Authors' Responses to Comments of Reviewer #1

General Comments: This work develops a Land-River-Ocean coupled model and evaluates its performance in simulating flood inundation through its application in the Pearl River Estuary. The results indicate that the model's simulation matches well with observations, demonstrating the potential practical application value of the developed model. Overall, this work leans more toward technical model development and evaluation, with relatively weaker scientific novelty. However, considering its practical application value, I recommend publication after revisions. Specific comments are as follows:

Authors' Responses to Comments of Reviewer #2

Figure R1. The wind stress coefficients at different water depths. Dashed lines with error bars are observations; solid lines are parametric equations and simulation results.

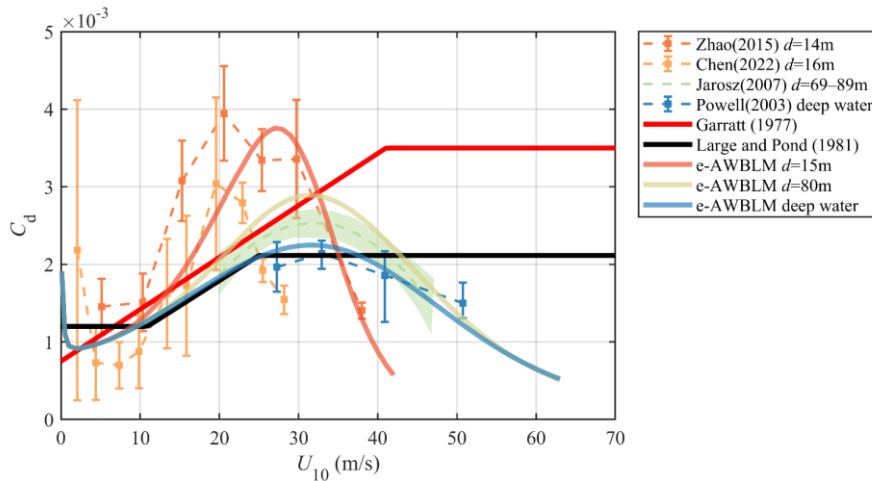
Comment 2. The model's advantage. The authors frequently mention the advantage of this coupled model in the text. For instance, in Lines 59-69, the authors state that previous models have simplified the coupling to some extent, whereas the model developed here has made no such simplifications. Similarly, in Lines 252-257, the authors claim that the accuracy of their model is higher than that of previous studies. They further suggest that one possible reason for the improved accuracy is the more comprehensive coupling in their model. I believe the highlight of this work is indeed the more comprehensive coupling. However, the authors do not provide any direct evidence to demonstrate that the improved simulation results are due to this comprehensive coupling. Simply comparing the results to previous studies is insufficient. The differences in simulation results could arise from many factors, such as

Thanks for the comment. In the model we developed, the description of the air-sea momentum transfer is really improved. In most of the existing storm surge models, the wind stress coefficient, which is a measure of the air-sea momentum flux, is estimated with empirical formulas proposed decades ago, e.g., the linear formula proposed by Garratt (1977) and Large and Pond (1981). However, most of the earlier formulas have been demonstrated to be incorrect under extreme wind conditions. Recent studies showed that the result of wind stress coefficient from the e-AWBLM agrees well with observations from deep to shallow water (Fig. R1; Zhang and Yu, 2024), and we fully coupled the e-AWBLM into our present model.

Figure R2. The simulated maximum surge levels are compared with observations in (a) Garratt (1977) and (b) e-AWBLM

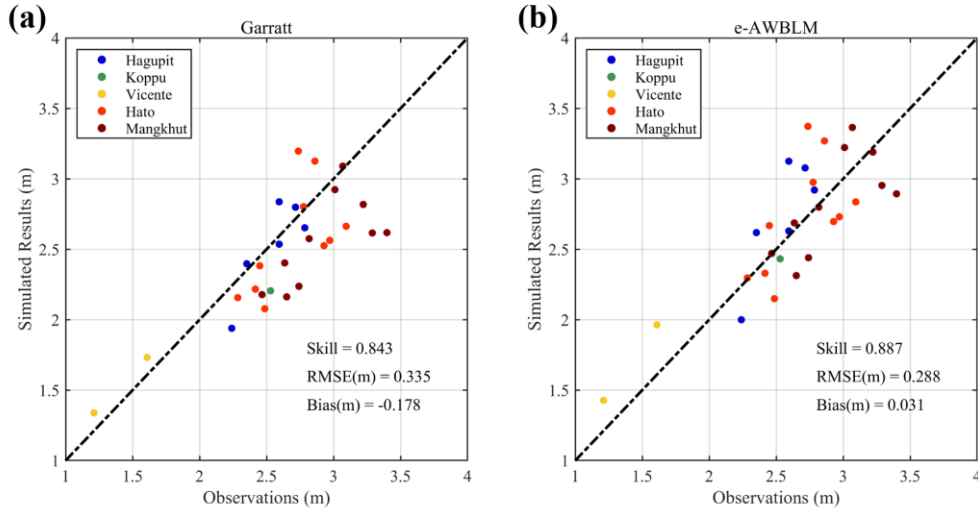
Comment 6. Line 230: In this section, the authors analyze the results for runoff, storm surges, and flood inundation, showing that the model performs well. However, as mentioned in Major Comment 2, the authors should conduct a more in-depth study of what aspects the model performs well in and what aspects it does not. For example, they could conduct sensitivity experiments to demonstrate which aspects are due to the coupling and which are due to accurate wind field data.

We applied the model we developed to the computation of the maximum surge level during several Typhoon events. In order to exclude the influence of non-model factors, tidal levels without adding the storm surge are well modeled to exclude the effects of topography and bottom friction on water levels (Figure 5). The wind speed and direction are well modeled to exclude the impact of atmospheric forcing (Figure S2-S6). Based on such obtained results,

verification of the effectiveness of the present model should be meaningful. We included simulation results using the default wind stress evaluation method in ADCIRC (Garratt, 1977). Overall, the maximum surge levels obtained with the e-AWBLM are more accurate than those obtained with Garratt (1977)'s formula. It is clear that Garratt (1977)'s formula significantly underestimates the maximum water level.

Thanks for the comment. As we mentioned when we response to comment 2, we highlighted our improvements in describing the air-sea momentum exchange (Figure R2) and the river-ocean interaction (Figure R3) in the revised manuscript. Improvement on the numerical accuracy of storm surge level simulation is also emphasized. We added some detailed explanations in the revised manuscript based on the reviewer's comments [Page 13, Lines 266-269, Lines 275-278; Page 14, Figure 6; Figure S7 in supporting material].

Figure R4. The contour plot (blue) of simulated inundation depth in Typhoon Mangkhut. The orange dots show the inundation range estimated by MODIS datasets.

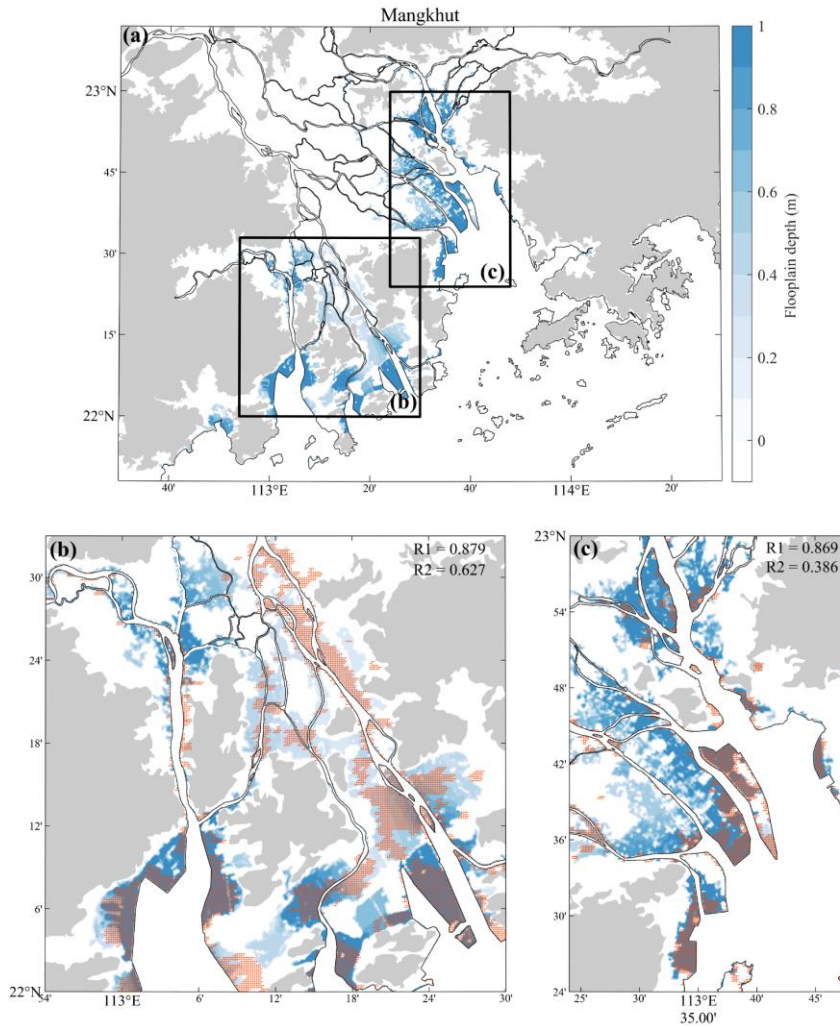
Comment 7. Figure 6: The upper subplot should also have the label. The comparison of flood inundation here seems overly qualitative. Could the authors provide some quantitative results to clarify the issue? For instance, what is the observed inundation area? What is the simulated inundation area? Are there significant differences between the two?

Thanks for the comment. We added a label on the upper subplot. In the revised manuscript, we introduce two metrics to assess the performance of the numerical model on describing inundation [Page 15, Lines 296-300]. As shown in Figure R4 and Figures S8-S11, the numerical model leads to satisfactory results on inundation areas. Most of the flooded regions identified by remote sensing are identical with the simulated results. Since the cloud cover removing technique in Tellman et al.'s (2021) method is known to result in an underestimation of the flooding area, it is reasonable to expect that the computed inundation range exceeds the observed area to some degree. We add the discussion of the inundation simulation results in the manuscript. [Page 15, Lines 296-307; Page 16, Figure 7; Figures S8-S11 in supporting material]

Figure R1. The simulated maximum surge levels are compared with observations in two methods: (a) Garratt (1977) and (b) e-AWBLM

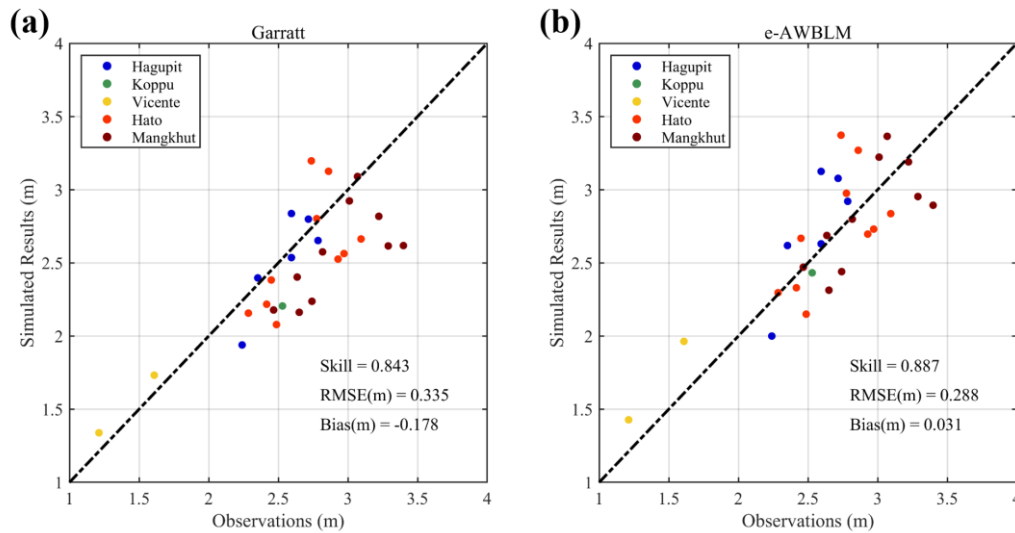
Comment 3. The manuscript demonstrates the advantages of two-way coupling by comparing

it with one-way coupling. It would be beneficial to further compare this model with existing coupled models, particularly the most advanced ones, and discuss its strengths and limitations, especially in terms of accuracy and efficiency.

Thanks for the comment. An important improvement of the model is the description of the air-sea momentum exchange. In most previous studies, the wind stress in the storm surge model is estimated with linear formulas, which oversimplify the air-sea interactions (Gori et al., 2020; Du et al., 2024). In order to compare our model with existing models, we added results from numerical experiments that use the default wind stress formula in ADCIRC (Garratt, 1977). The maximum storm surge level is compared in Figure R1. It is evidently shown that the maximum storm surge levels obtained with the e-AWBLM are more accurate than the default method. The limitations of the proposed model are mentioned in our response to Comment 1. We added some discussions in the revised manuscripts based on the reviewer's comments [Page 13, Lines 266-269; Figure 6].
